Amendments to the Drawings

REMARKS / ARGUMENTS

Appl. No. 10/788,833
Amdt. dated 03/28/2005
Reply to Office action of 11/28/2005

Figure 5B

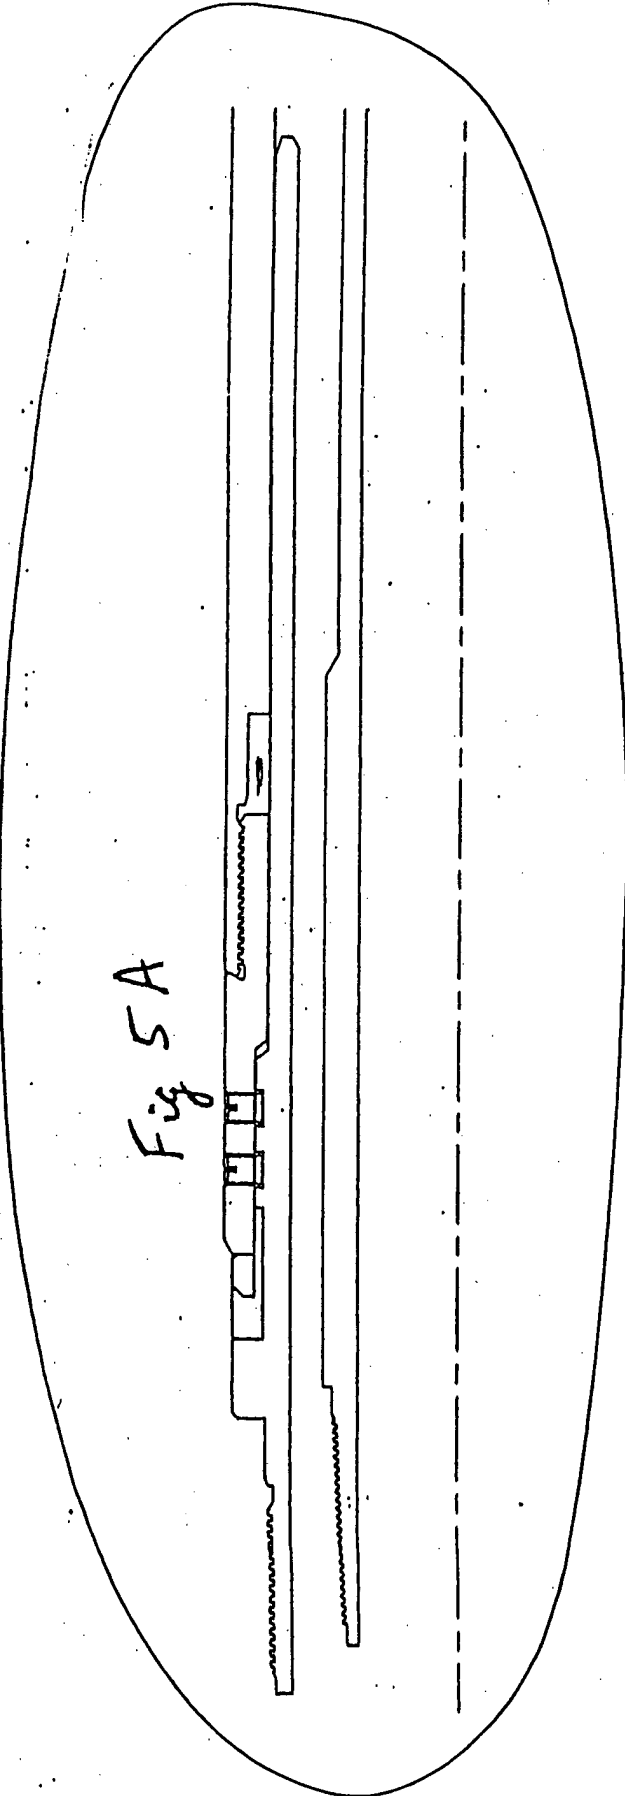
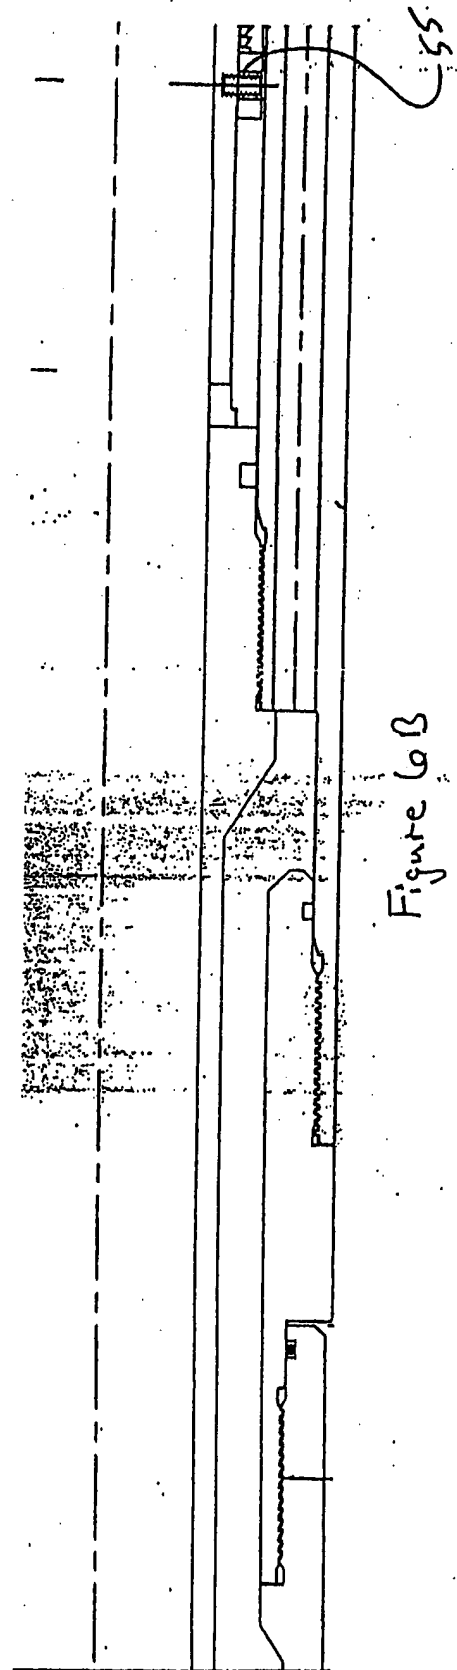
1. The drawings are again objected to because in Figures 5A-5E and 6A-6E each corresponding "figure" is actually only one figure and should be labeled as such, i.e. Figures 5AA and 6A are the same figure and should be labeled as one figure. The examiner recognizes that applicant is attempting to compare the location of the different elements of the tool for two different tool positions, i.e. open and closed as described in the Brief Description of the Drawings, however, this comparison can be shown in only one figure (see 37 CFR 1.84). The actual figures themselves need not be changed but only labeled as a single figure and the Brief Description of the Drawings changed accordingly. Corrected drawing sheets in compliance with 37 CFR 1.121(d) are required in reply to the Office action to avoid abandonment of the application. Any amended replacement drawing sheet should include all of the figures appearing on the immediate prior version of the sheet, even if only one figure is being amended. The figure or figure number of an amended drawing should not be labeled as "amended." If a drawing figure is to be canceled, the appropriate figure must be removed from the replacement sheet, and where necessary, the remaining figures must be renumbered and appropriate changes made to the brief description of the several views of the drawings for consistency. Additional replacement sheets may be necessary to show the renumbering of the remaining figures. Each drawing sheet submitted after the filing date of an application must be labeled in the top margin as either "Replacement Sheet" or "New Sheet" pursuant to 37 CFR 1.121(d). If the changes are not accepted by the examiner, the applicant will be notified and informed of any required corrective action in the next Office action. The objection to the drawings will not be held in abeyance.

It is first noted that the Brief Description of the Drawings specifically indicates that Figures 5 and 6 show the same valve only Figure 5 shows the valve in the open position and Figure 6 shows the valve in the closed position. Depicting this difference is allowed in a single figure such as that shown in the figure labeled Figures 5 and 6, however, this figure must only be given one label as a figure can only have a single label (see 37 § CFR 1.84(u)). If applicant wishes the open and closed positions to remain separate figures then the figures must be amended to remove the centerline and place space between

the two figures. The current depiction is considered to be only one figure. Secondly, if applicant considers Figures 5 and 6 to be structurally different then they need to be depicted as two separate figures. This can be done as indicated above.

1. The drawing sheet containing Figures 5A and 6A has been amended by repositioning Figure 5A on the sheet and adding a centerline for Figure 5A.
2. The drawing sheet containing Figures 5B and 6B has been amended by repositioning Figure 5B on the sheet and adding a centerline for Figure 5B.
3. The drawing sheet containing Figures 5C and 6C has been amended by repositioning Figure 5C on the sheet and adding a centerline for Figure 5C.
4. The drawing sheet containing Figures 5D and 6D has been amended by repositioning Figure 5D on the sheet and adding a centerline for Figure 5D.
5. The drawing sheet containing Figures 5E and 6E has been amended by repositioning Figure 5E on the sheet and adding a centerline for Figure 5E.

Because Figure 5 illustrates an embodiment of the invention in the opened condition and Figure 6 illustrates a closed condition, Applicant considers them to be structurally different. Therefore, Applicant has amended these Figures to present them with separate centerlines. The undersigned thanks the Examiner for the detailed explanation and guidance, and regrets any inconvenience his prior responses may have caused.
